CITY OF
TUCSON

Subject: Minor Amendment to Valencia Crossing PAD Regarding Spine Road Relocation

SUBJECT: VALENCIA CROSSING PAD 21
SPINE ROAD LOCATION
JN 3795-A

Exhibit III.A: Land Use Concept Plan

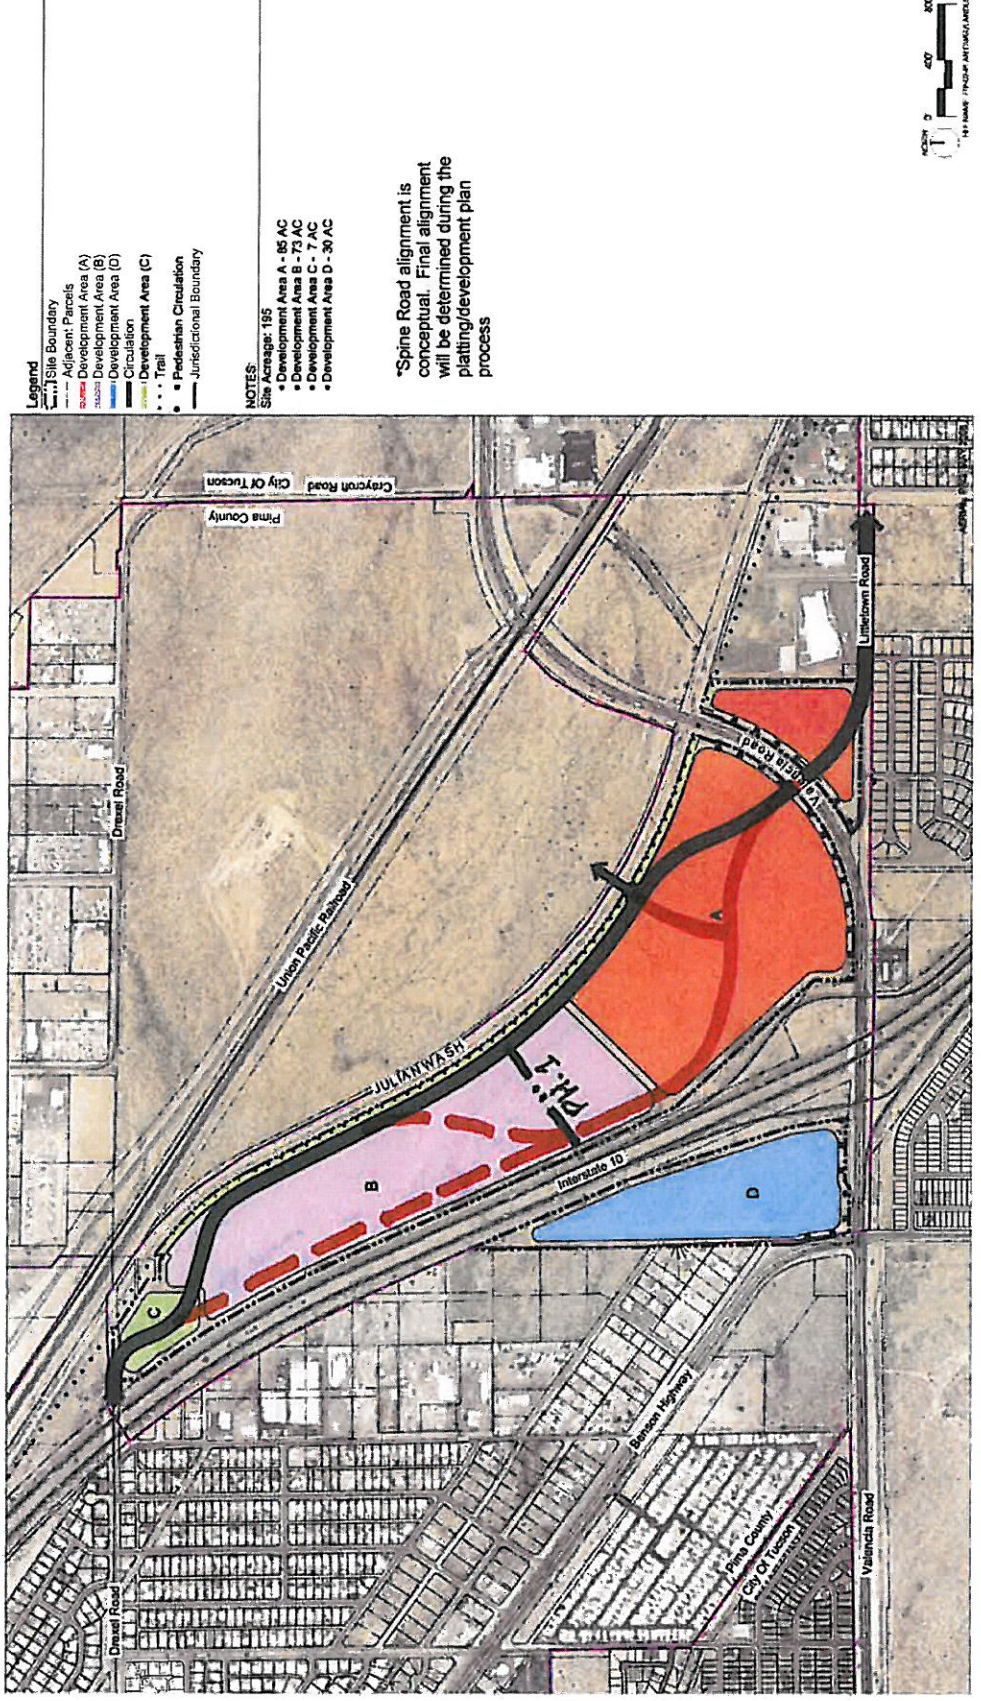
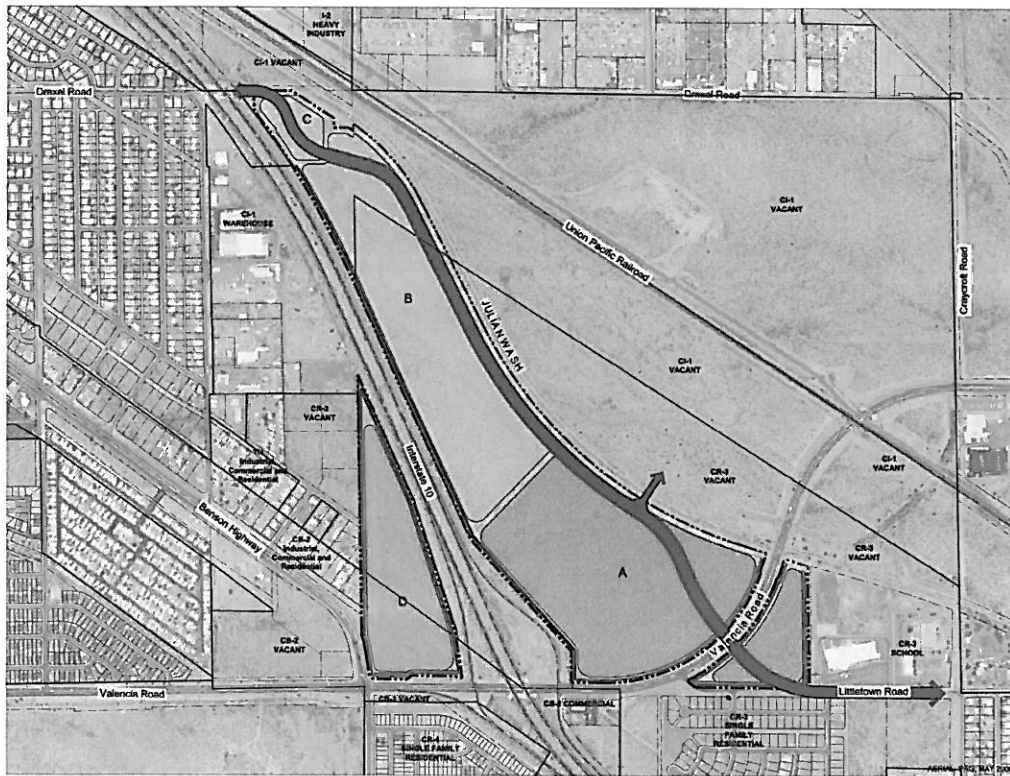
It should be noted that prior to development of any area within the Valencia Crossing PAD, detailed development and design standards will be submitted as an extension of the PAD document. The submitted revised exhibits are consistent with the goals and objects of the Valencia Crossing PAD, including the added language that the Spine Road alignment is conceptual and will be determined during platting/development plane process:

- Exhibit III.A: Land Use Concept Plan
- Exhibit III.D: Landscape Border Plan
- Exhibit III.E: Post-Development Hydrology
- Exhibit III.G.3: Proposed Vehicular, Bicycle & Pedestrian Circulation

Therefore, the minor amendment is approved as a non-substantial change, consistent with the Valencia Crossing PAD.

Exhibit III.D: Landscape Border Plan

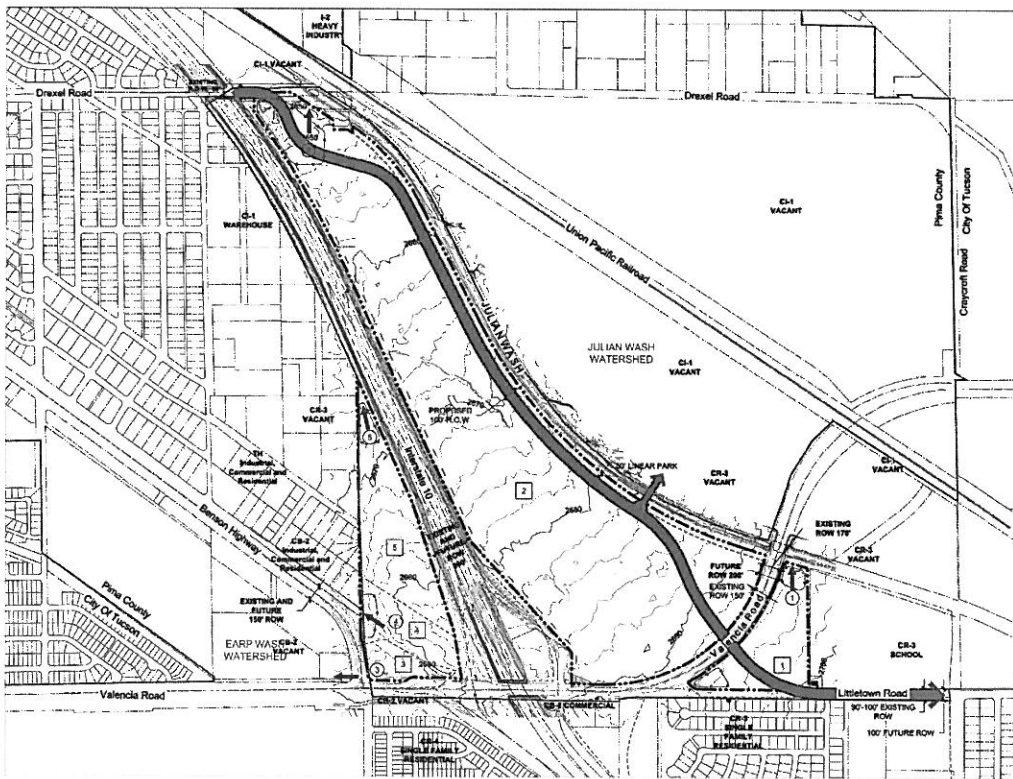
*Spine Road alignment is conceptual. Final alignment will be determined during the platting/development plan process

Exhibit III.E: Post-Development Hydrology Concept

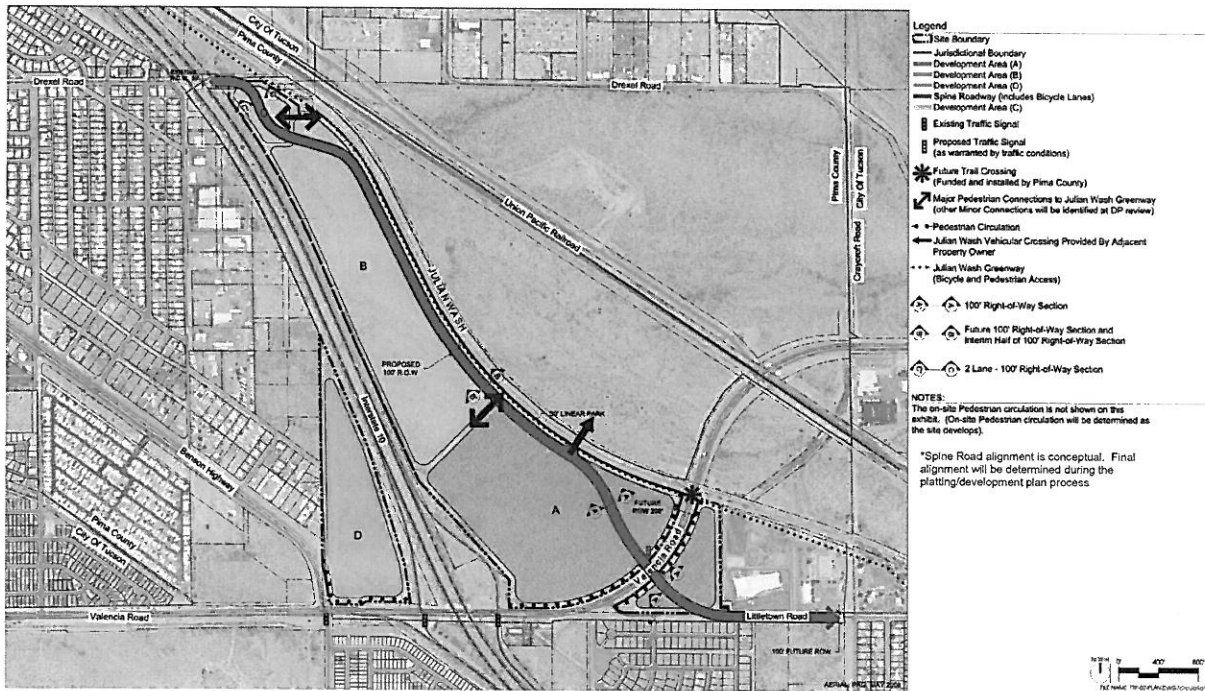
*Spine Road alignment is conceptual. Final alignment will be determined during the platting/development plan process
